Point Beach Nuclear Plant, Units 1 and 2
Dockets 50-266 and 50-301
Renewed License Nos. DPR-24 and DPR-27

License Amendment Request 261
Extended Power Uprate
Response to Request for Clarification

LICENSE AMENDMENT REQUEST 261 EXTENDED POWER UPRATE RESPONSE TO REQUEST FOR CLARIFICATION

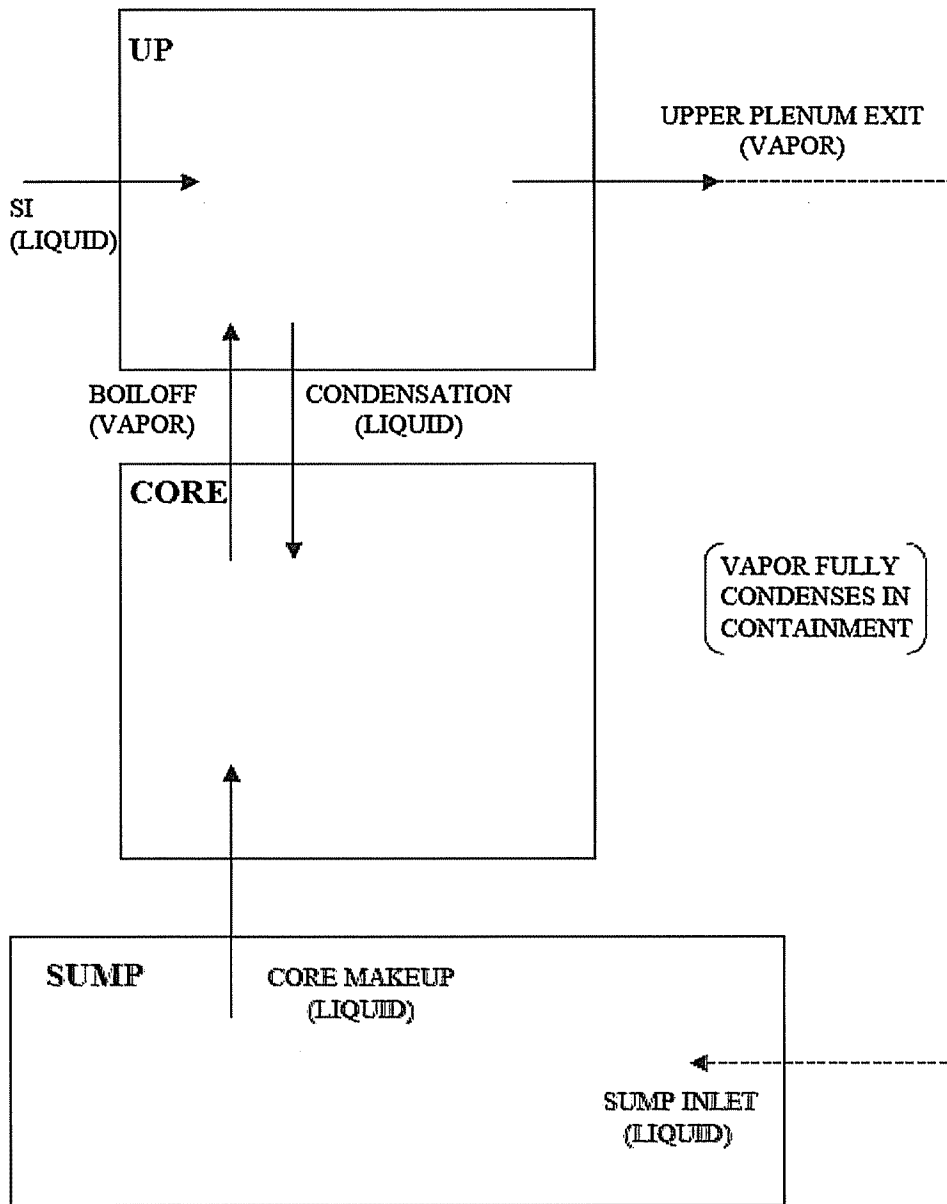
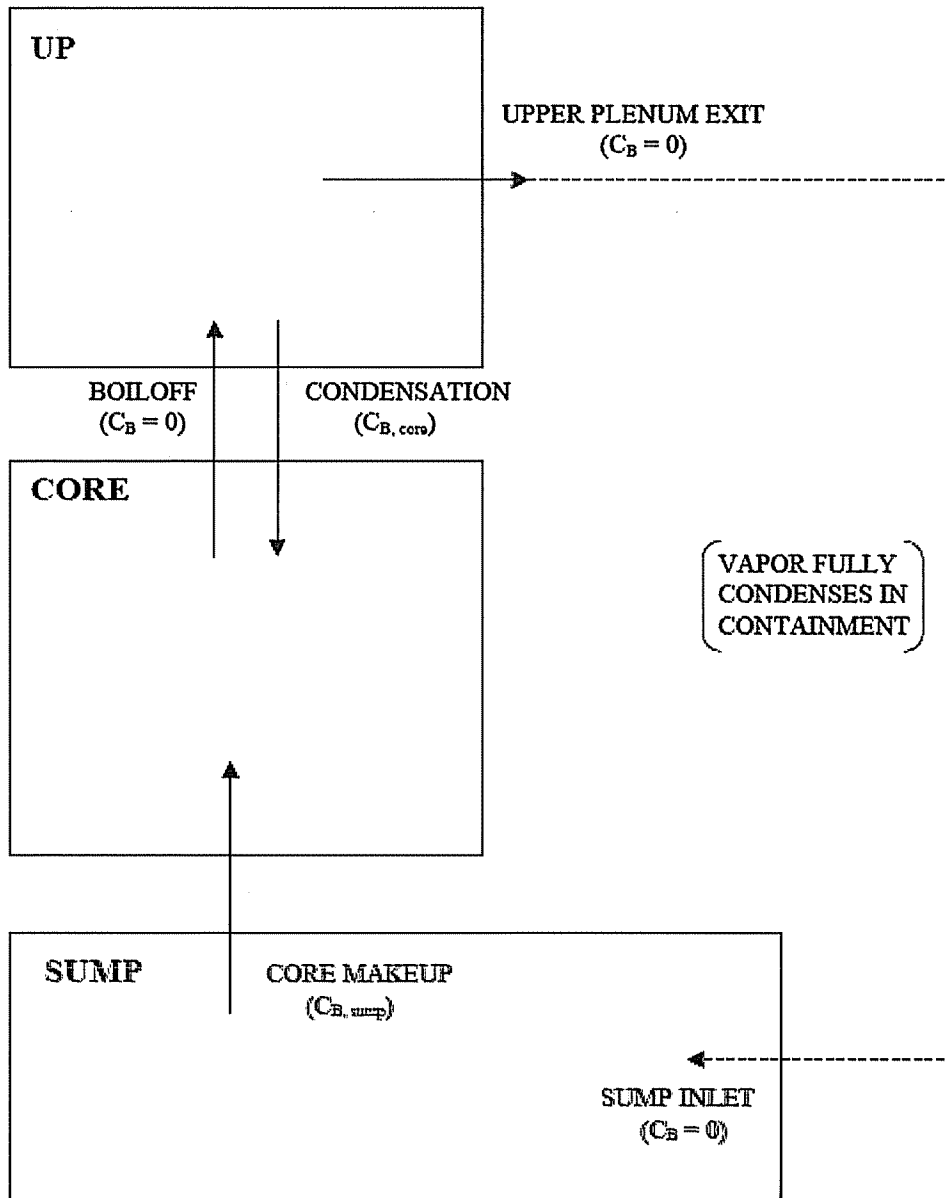
Please describe the models and method utilized to compute the boric acid concentration in the sump following sump re-circulation that is used as a boric acid source during the recirculation mode of injection.

Describe how the vapor source to the containment from the reactor coolant system is computed, the resultant condensation, and hence the boric acid content of the sump.

A typical SKBOR calculation considers two volumes: one representing the effective vessel mixing volume (denoted as the CORE); and one representing the remaining system inventory (denoted as the SUMP). The CORE and SUMP are initially assumed to contain borated liquid at the system-average boron concentration. Vapor generated due to decay heat boiling exits the CORE with a boron concentration of zero (vapor is assumed to condense fully in containment) and is returned to the SUMP as unborated liquid (see additional discussion below). Borated liquid is added from the SUMP as required to keep the CORE volume full. In this way, the

SUMP boron concentration gradually decreases, while the CORE boron concentration increases toward the boric acid solubility limit. The logic of the mass and boron calculations in SKBOR is shown in Figures 1 and 2.

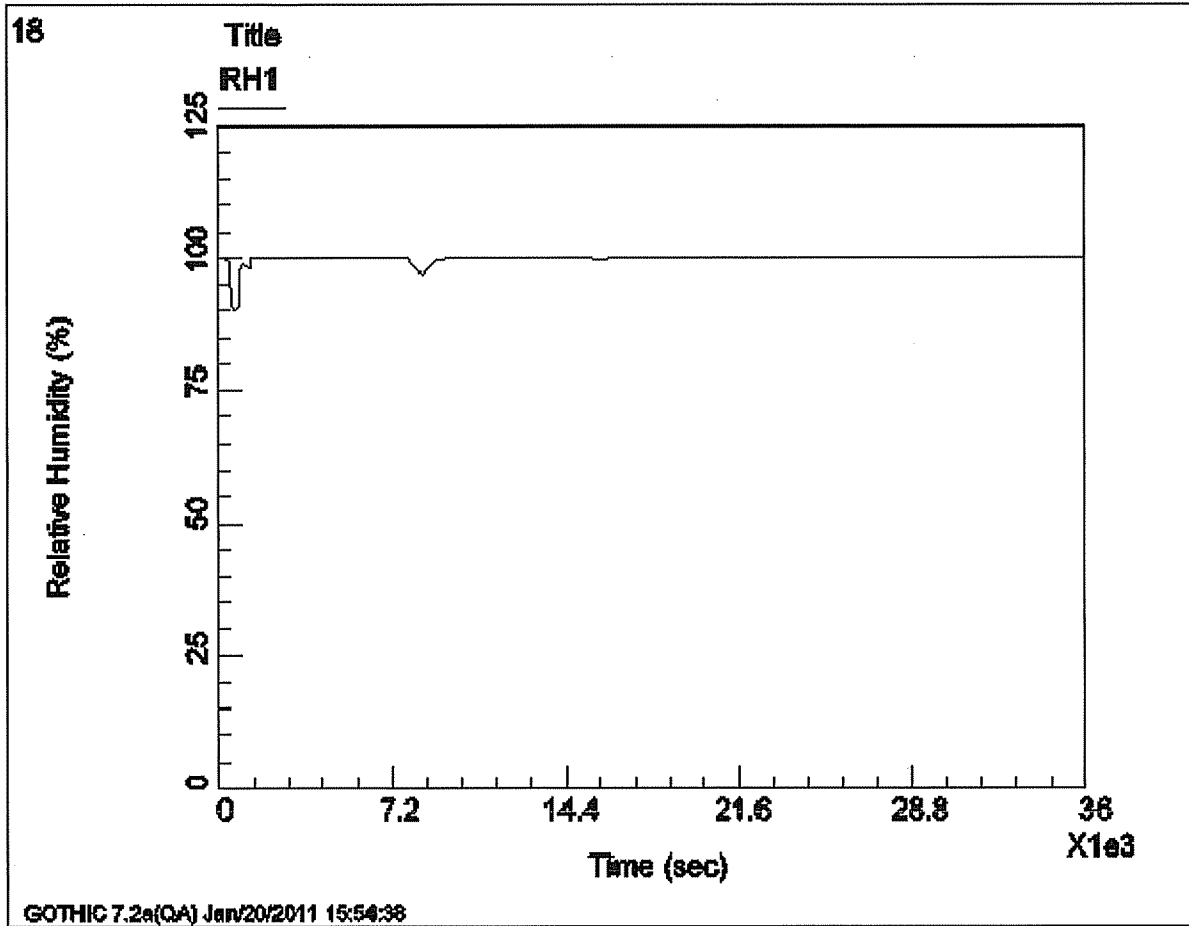
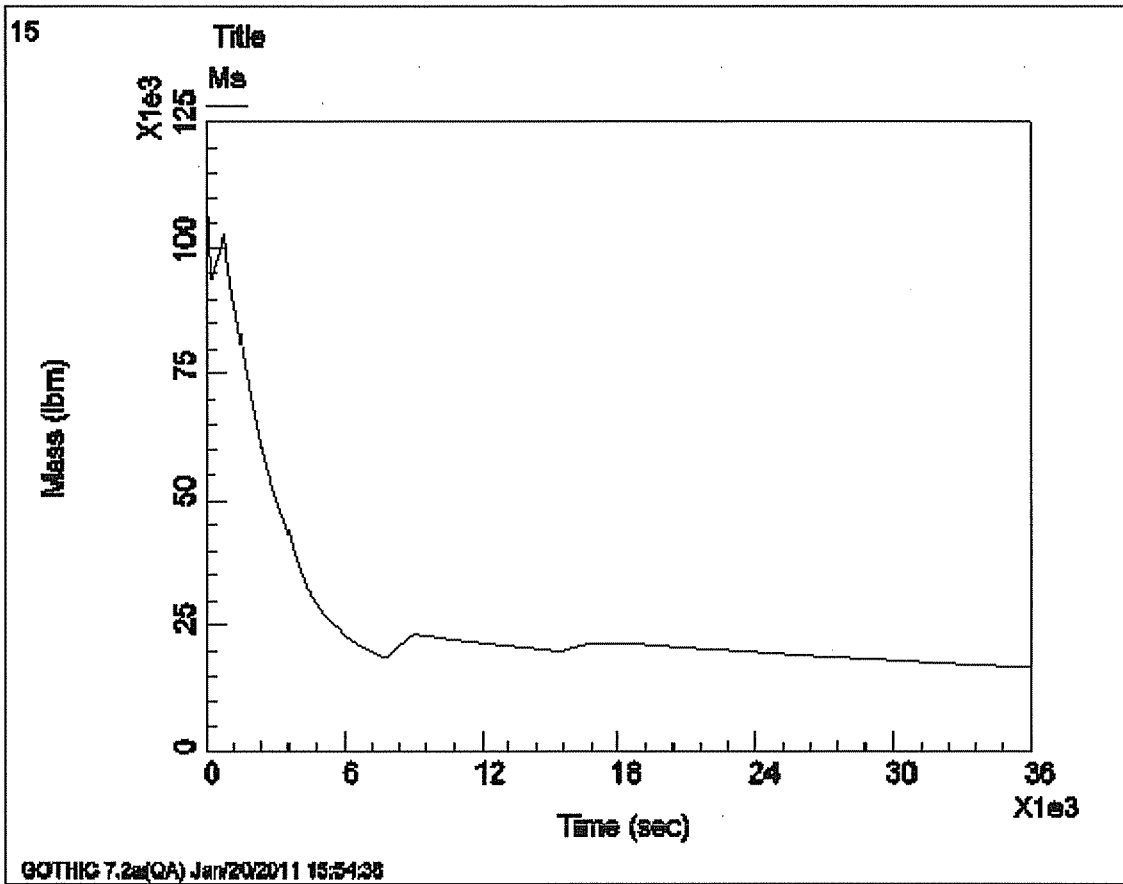
If 100% of the vapor source to the containment is assumed, then provide the basis and justification for this assumption.

If appropriate, please reference relevant containment transient data for the condensation efficiency of the containment sprays and CAR fans.

As described above SKBOR assumes that vapor generated in the core returns to the sump as unborated liquid (i.e. 100% condensation). The containment will reach saturated conditions (100% relative humidity) very quickly after the pipe break. At this point, since the containment atmosphere cannot hold any more water vapor, 100% of the steam generated in the core will condense. The amount of water vapor in the containment atmosphere, both before and after the pipe break is small relative to the amount of water in the sump. These assumptions are validated by examining the predicted conditions from the PBNP EPU LOCA Containment Analysis (Figures 3 and 4).

Figure 3 shows the relative humidity versus time for the limiting LOCA containment pressure analysis. As indicated, the relative humidity in containment rises to 100% very quickly, within seconds of the pipe break. There are several dips from 100% relative humidity related to the relatively rapid changes in containment pressure. The assumption that the amount of water vapor in the containment atmosphere is small relative to the amount of water in the sump can be justified by examining Figure 4, the containment water vapor mass (or steam mass) as a function of time after a large break LOCA. The maximum containment steam mass is approximately 100,000 lbm very early in the transient, and falls to approximately 25,000 lbm after about 3600 seconds. The water vapor mass in the containment atmosphere before the LOCA is approximately 1000 lbm. Thus, it is demonstrated that the containment atmosphere's retention of water vapor mass is small compared to the total water mass in the sump (approximately 2,700,000 lbm). The transients in Figures 3 and 4 are modeled assumptions to maximize containment pressure. A more representative condition for limiting boric acid precipitation scenarios would be a minimum containment pressure transient which is consistent with the minimum containment pressure assumption used in the boric acid precipitation analysis. Lower containment pressure would reduce the potential containment atmosphere retained water mass from what is indicated in Figure 4. The effect of 50,000 lbm of water vapor mass retained in the containment atmosphere on computed hot leg switchover (HLSO) time was examined by reducing the pure water mass in the SKBOR initial sump conditions. The effect on boric acid buildup in the core was small (time to reach 29.27 wt% boric acid concentration was 4.71 hours versus 4.82 hours).
